# Access Compliance Report

## Public Rights-of-Way

### (Curb Ramps)

| Intersection ID: 12011 | Main Street: E_16TH_ST | Cross Street: HARRILL_ST | Location: E            |

| ADA ID: 44DF627CD143   | Ramp Type: PerpDiag    | Initial Pass/Fail: Fail  | Overall Compliance: No |

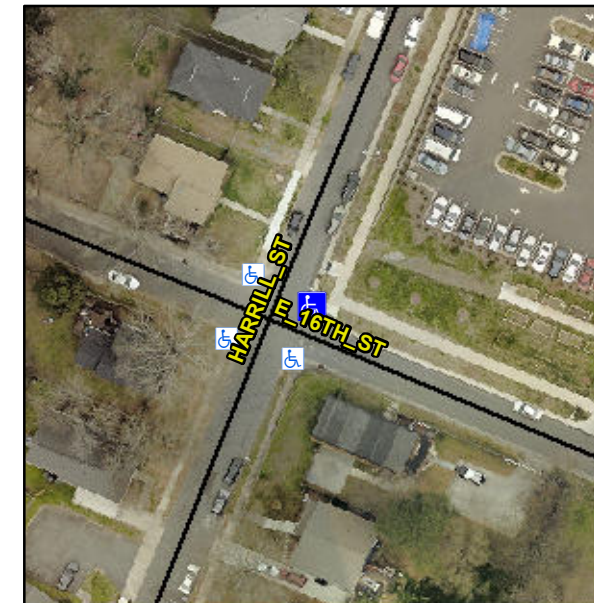
**Not Found, R304.5.1**

| Compliance | Description           | Data  | Compliance | Description                 | Data  |
|------------|-----------------------|-------|------------|-----------------------------|-------|
| No         | Ramp Width (in)       | 41.0  | Yes        | Ramp XSlope (%)             | 0.5   |

**Remove & Replace Curb Ramp With Two New Directional Ramps or Equivalent.**
